RE: RESPONSE TO FURTHER ADVICE NOTICE-297 SHERBROOKE ROAD, WILLOWONG QLD 4110

COUNCIL REF: A007001387

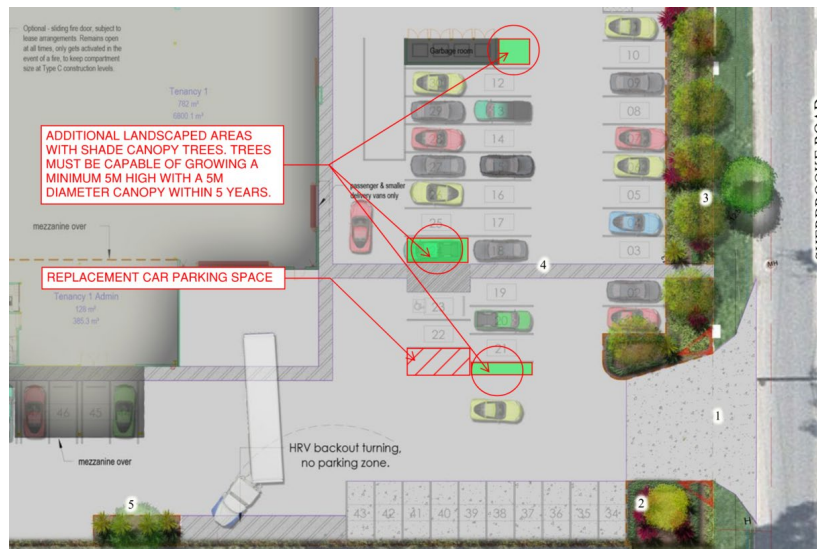
1. In accordance with AO18/PO8 and AO19.1, AO19.2, AO19.3/PO19 of the Transport, access, parking and servicing code provide amended plans and supporting documents which address the following requirements:
 - a. Provide RPEQ swept path analysis which demonstrates all onsite manoeuvring of the RCV inclusive of ingress, egress and travel path to servicing location.
 - b. Provide updated RPEQ RCV swept paths which demonstrate a kerb-to-kerb of 9.757m as per BSD-3008 sheet 2 of 2 or provide clarification from an RPEQ that the steering angle utilised to generate the swept path is equivalent to a kerb-to-kerb radius of 9.757m

Council’s advice is noted. A swept path assessment was undertaken for the Brisbane City Council TAPS Code Rear Lift Refuse Collection Vehicles. The assessment demonstrates the full refuse collection movement, including ingress from Sherbrooke Road, internal travel to the refuse collection area, manoeuvring adjacent to the bin enclosure, standing/servicing position, and egress back to Sherbrooke Road.

The updated assessment confirms that that both the RCV refuse collection movement and the critical 19m AV servicing movement can be undertaken safely and effectively within the site. Both vehicles can enter, manoeuvre, service/load, and depart in accordance with the intended operational arrangement while maintaining the required 300mm clearance buffers. Please refer to Attachment B for further details.

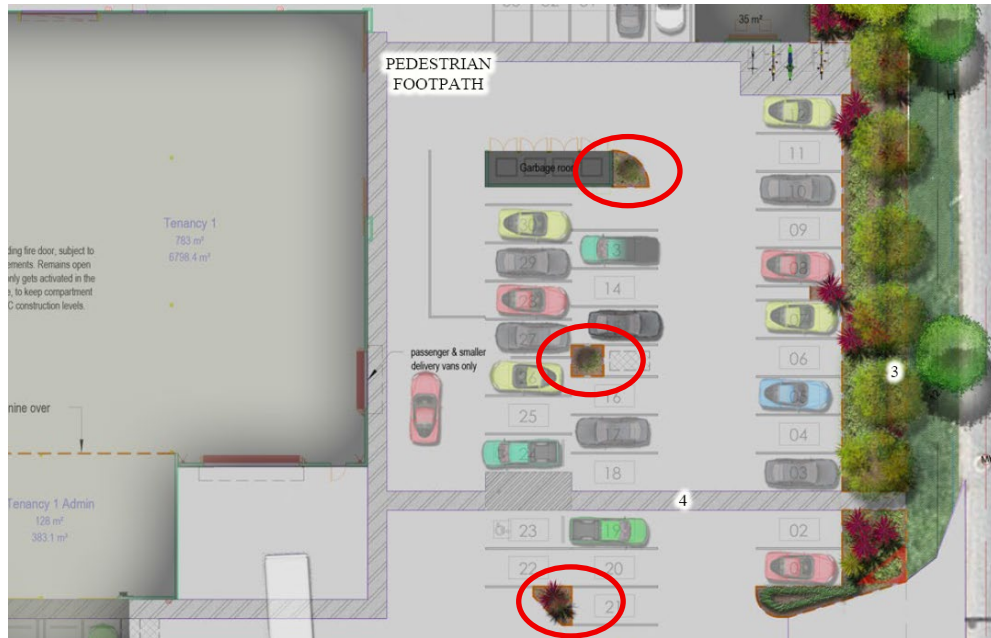
2. Submit amended plans showing shade trees at a rate of one per six car parking spaces in the at-grade parking area in accordance with AO13.3/PO13 of the Industry code to complement the scale and bulk of the industrial form, as recommended below:

While Council’s further advice is noted. The indicative location for shade trees recommended by Council would likely result in a loss of 2 car spaces. To avoid this, alternative locations have been proposed (See Attachment C) which would allow for the retention of the car spaces while also satisfying AO13.3/PO13.3 the Brisbane Planning Scheme (i.e 3 trees for 18 car spaces). Please refer to the below image showing the shade tree locations.
